**RE: Mesa Del Sol Neighborhood - Montage Units 3 & 4  
Drainage Report for Preliminary Plat Approval and Grading Permit  
Engineer's Stamp Date 6-6-2014 (File: R16D006)**

Based upon the information provided in your submittal received 6-6-14, the above referenced Drainage Report is approved for Preliminary Plat action by the DRB, but cannot be approved for Grading Permit until the following comments are addressed:

**MESA DEL SOL MONTAGE UNIT 3  
GRADING AND DRAINAGE PLAN  
OVERALL**

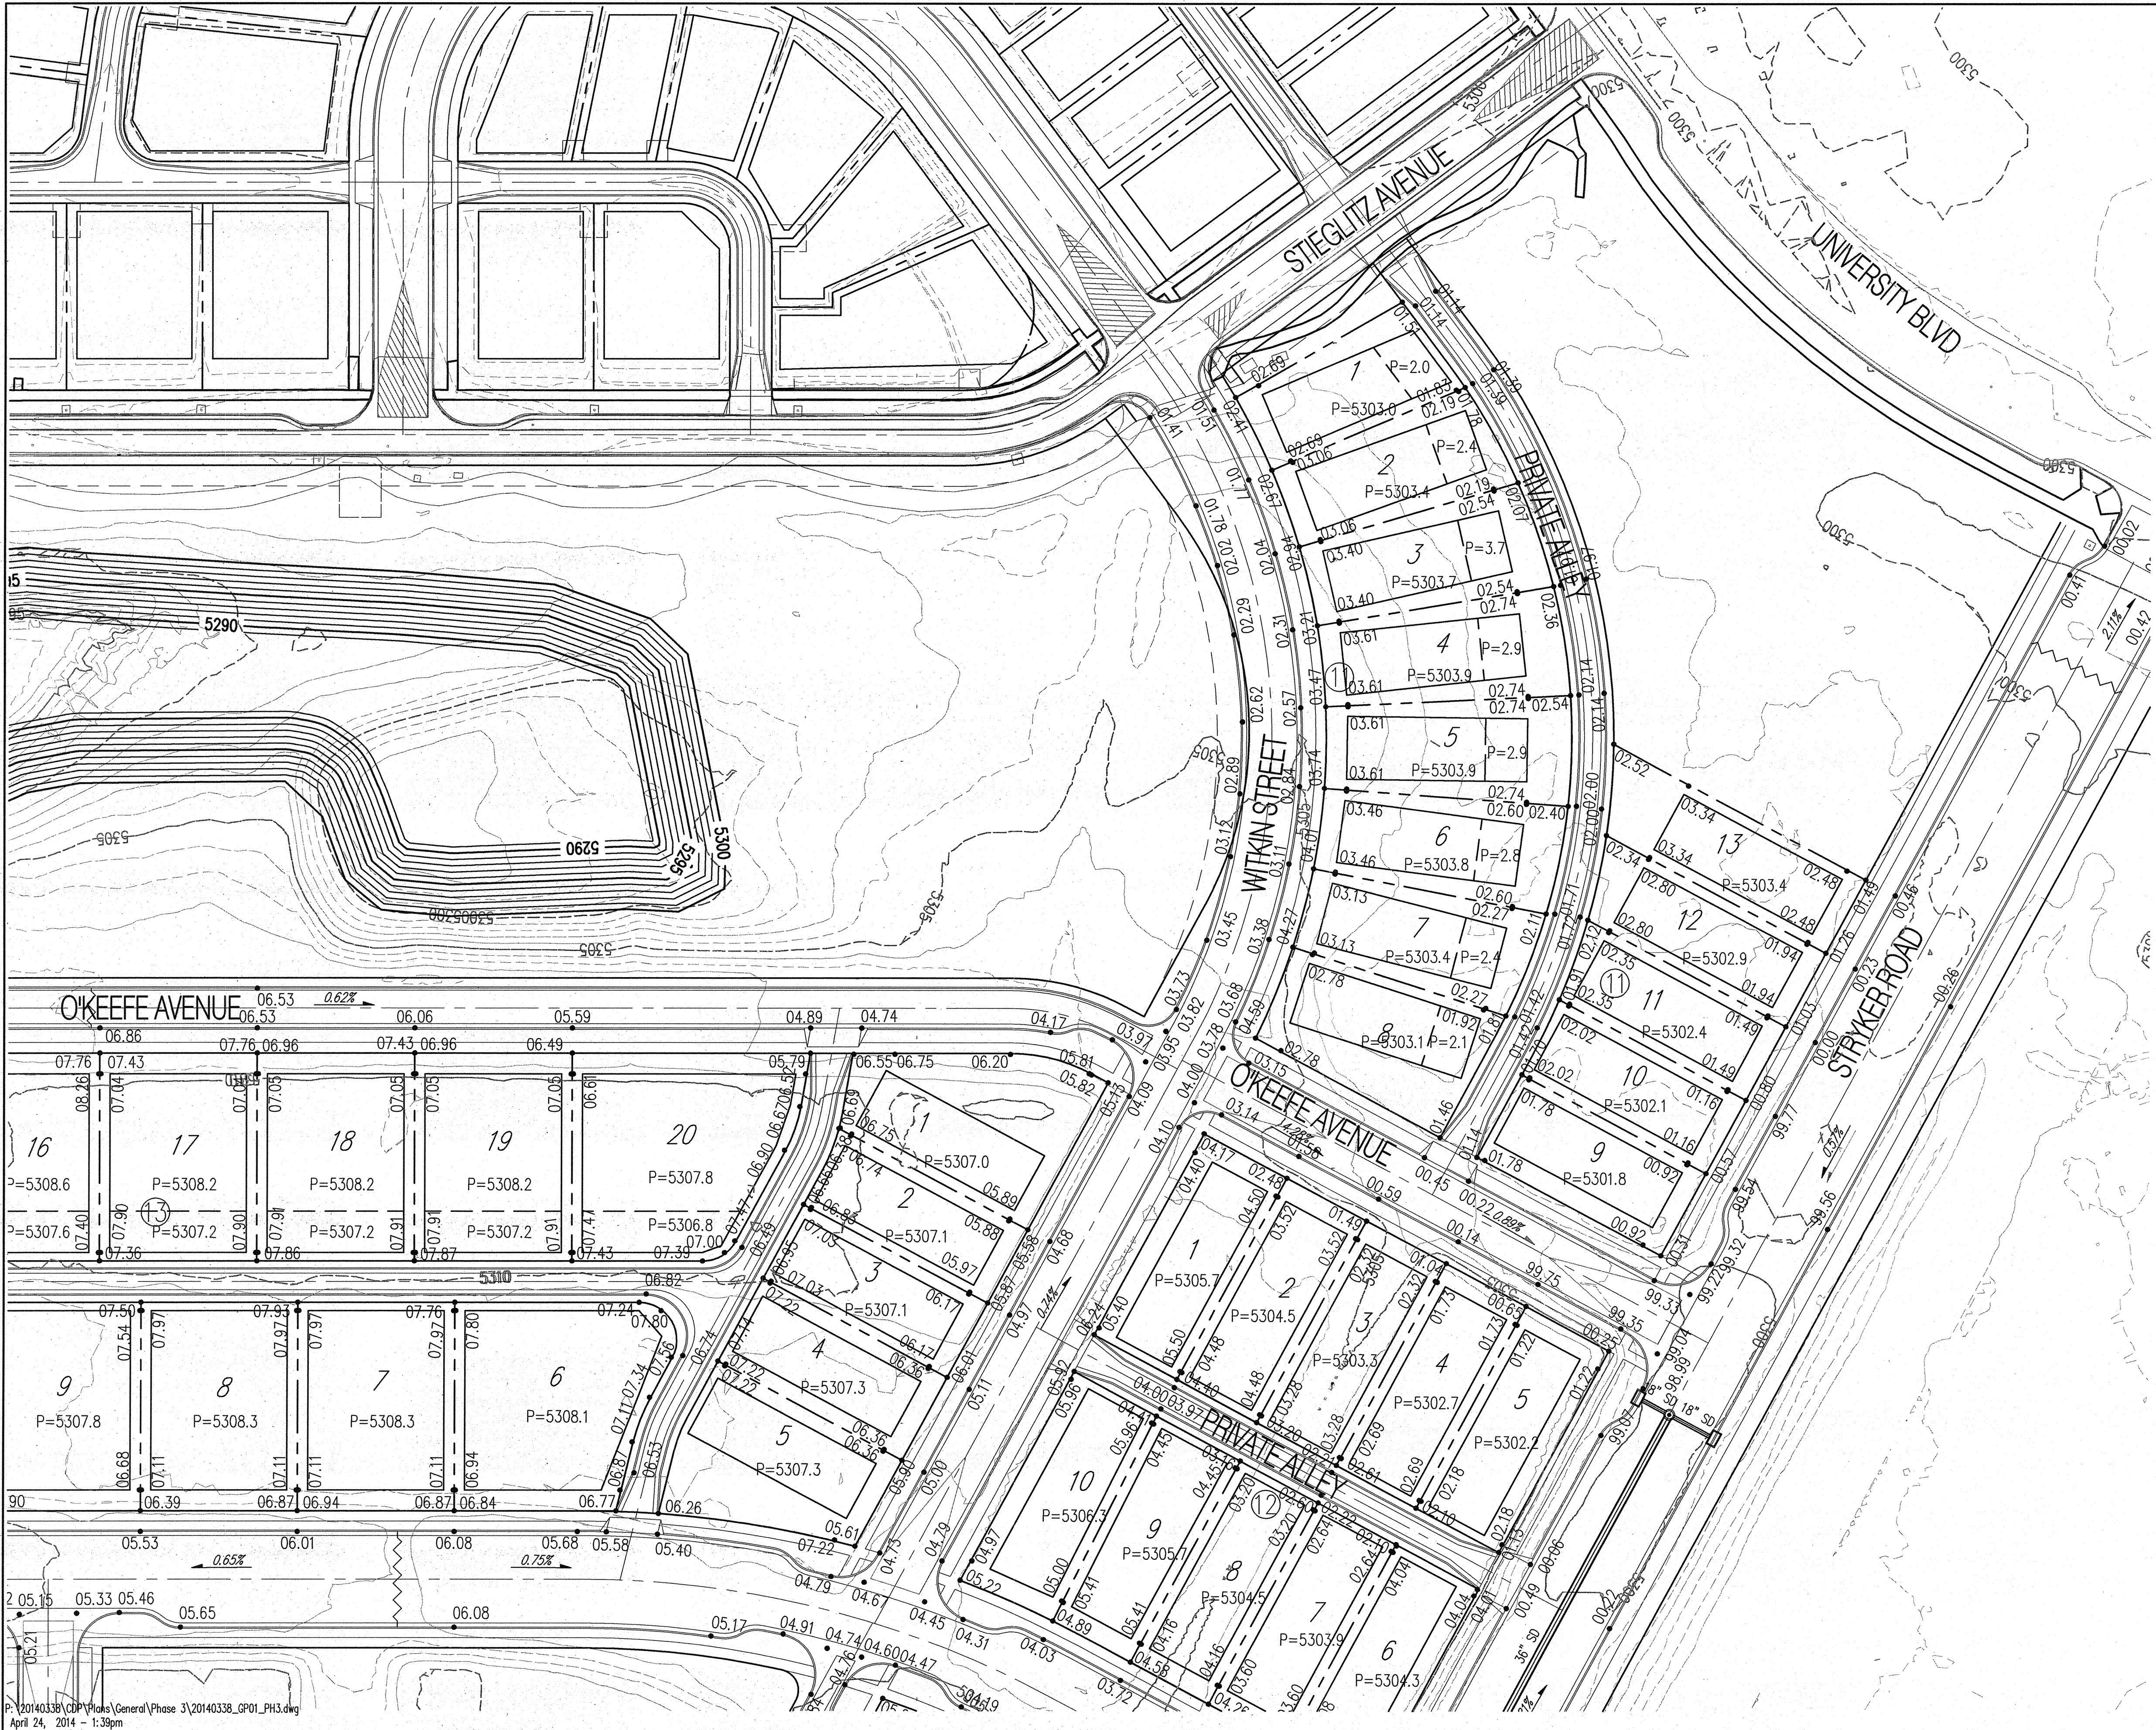
1. Is the development intended to be phased? If Montage 3A and 3B are built first, how are offsite flows managed in the interim?
2. Regarding phasing, the SD line that extends into Rothko Avenue should be capped when constructing Montage 3A and 3B, and subsequently constructed when Montage 4 is developed. Does Strand Loop have the capacity to convey offsite flows during the interim?

3. How will offsite basins draining away from the development be graded so that they drain as intended? Temporary Berms?
4. How will offsite basins draining into the development be graded so that they do not deposit sediment into the development? Temporary sediment ponds?

5. Show grading for all ponds used or modified in this project.
6. If Inlets 5, 6, 11 & 12 work in combination in a sump condition, then show what inlets will be built to support the interim condition, and show calculations for interim condition. Will a curb be needed for the interim condition?

7. How is runoff from Basin C conveyed to Pond 2A in the interim?
8. Show Street slope on Dasburg Drive, between Stryker and Raushenberg/
9. Slope of lateral pipes SDP51 and SDP52 are rather high and should be addressed at DRC.

10. Spot elevations on Lots 10 and 11 (south side) on SW corner of Strand and Stryker need to be verified.
11. Inlet #18 should be changed to IN18 (rather than IN15) on Storm Drain plan.

12. Verify spot elev. on east side of Lot 3 on SE corner of Stryker and Oldenburg.
13. How is open area north of Witkin Street to be graded?

14. Pond detail sheet shows an outlet pipe for overflow. Are these outlet pipes already in place for ponds 2A, 2B, and 3? If so, please locate them on the Grading plan and show where the overflow discharges to. If not, take outlet pipe out of Pond detail sheet, or indicate for which ponds the outlet pipe detail applies.
